**Rezoning Transportation Analysis**  
**Petition Number: Insert Zoning Petition #2021-161**  
*General Location Identifier: 22902119*

**From: Brandon Brezeale, PE**  
Brandon.Brezeale@charlottenc.gov  
704-432.5561

**Reviewer: Alfred Oyoyo**  
Alfred.Oyoyo@charlottenc.gov  
704-534-5572

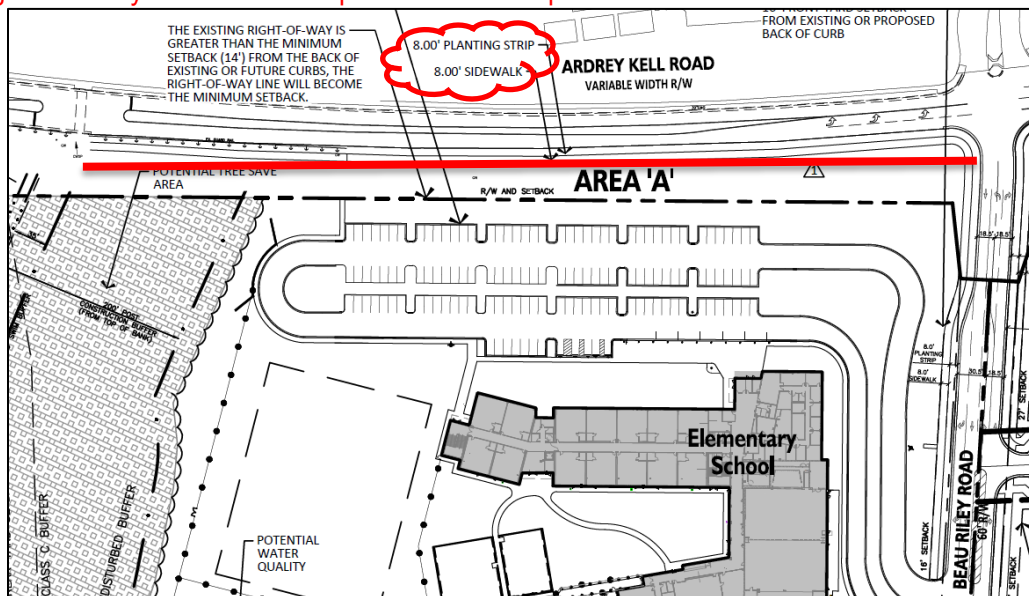
**1. ~~Curbline:~~**

- a. ~~**Ardrey Kell Road:** The existing curb and gutter is in its future location. No curb relocation required.~~
- b. ~~**Beau Riley Road:** The existing curb and gutter is in its future location. No curb relocation required.~~

~~Label and dimension the curb and gutter from the centerline for each road on the site plan.~~

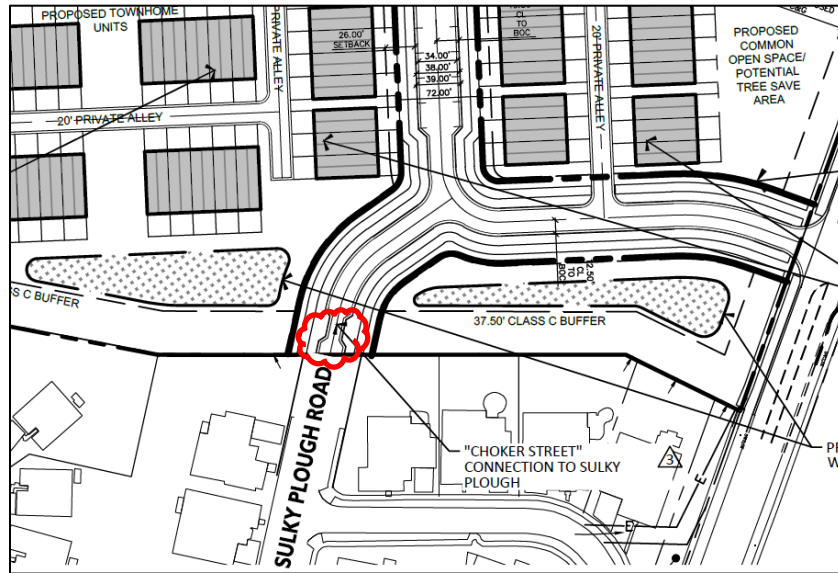
**Update to Comment from 11/22/21:** (site plan dated 12-13-2021): ~~Charlotte BIKES policy requires bikes to be accommodated along Ardrey Kell Road. Provide a 12' Multi-Use path along entire frontage on Ardrey Kell Rd.~~ Add conditional note committing to constructing the multi-use path along entire frontage on Ardrey Kell Road as depicted on the site plan.
